APPLICATION NO.	FILING DATE	FIRST NAMED INVENTOR	ATTORNEY DOCKET NO.	CONFIRMATION NO.
10/600,710	06/23/2003	Shigekazu Nagai	CS-22-030623	5749
22712	7590	02/21/2006		
PAUL A. GUSS PAUL A. GUSS ATTORNEY AT LAW 775 S 23RD ST FIRST FLOOR SUITE 2 ARLINGTON, VA 22202				EXAMINER KRAUSE, JUSTIN MITCHELL
				ART UNIT 3682 PAPER NUMBER

Office Action Summary	Application No.	Applicant(s)	
	10/600,710	NAGAI ET AL.	
	Examiner	Art Unit	
	Justin Krause	3682

DETAILED ACTION

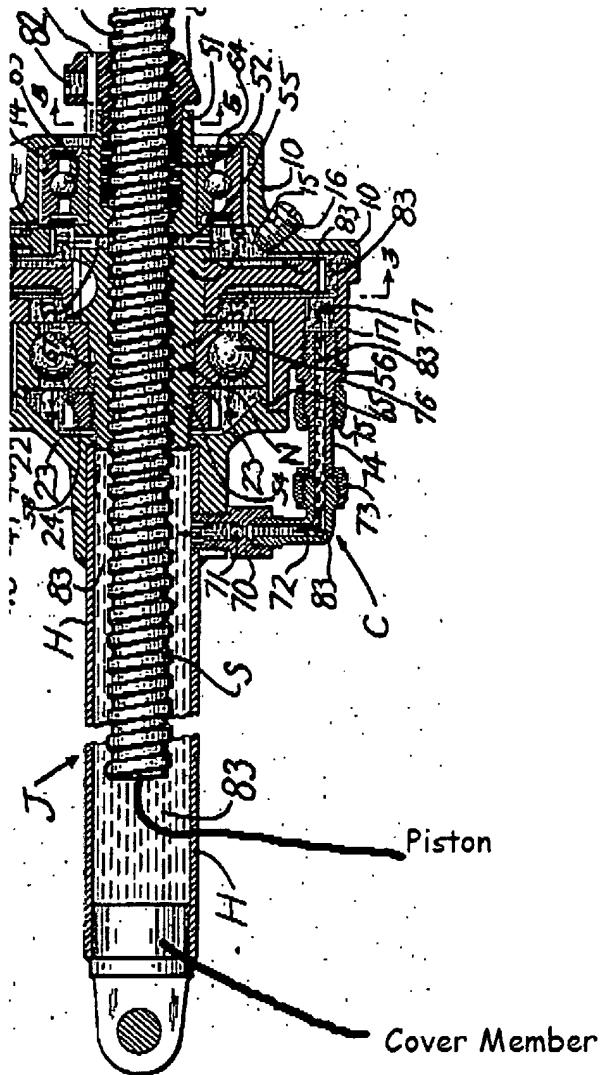
- A main body unit (A,H)
- A rotary driving source (M) which is connected substantially in parallel to an axis (Fig 1) of said main body unit and rotated in accordance with an electric signal
- A gear mechanism (G), which transmits rotary driving force of said rotary driving source
- A feed screw mechanism (N, S), which converts rotary motion transmitted by said gear mechanism into rectilinear motion and which includes a feed screw shaft (S) provided movably back and forth within said main body unit and projecting outside of said main body unit
- said feed screw mechanism including a feed screw nut (N) which is externally fitted to said feed screw shaft to be meshed with said gear mechanism and

which is integrally formed with a gear section (37) having a plurality of teeth arranged circumferentially about said gear section -wherein said main body unit includes a tube member (H) and a pair of cover members (23 or 80 and the plug on the left side of tube member H, see image below) and a piston (enclosed end of S, see Col 2, line 40-Col 3 line 5, image below) which is slidably displaceable along an inner wall surface of said tube member, is connected to an end of the feed screw shaft. The feed screw shaft acts as a piston, so the piston is inherently connected to the feed screw shaft.
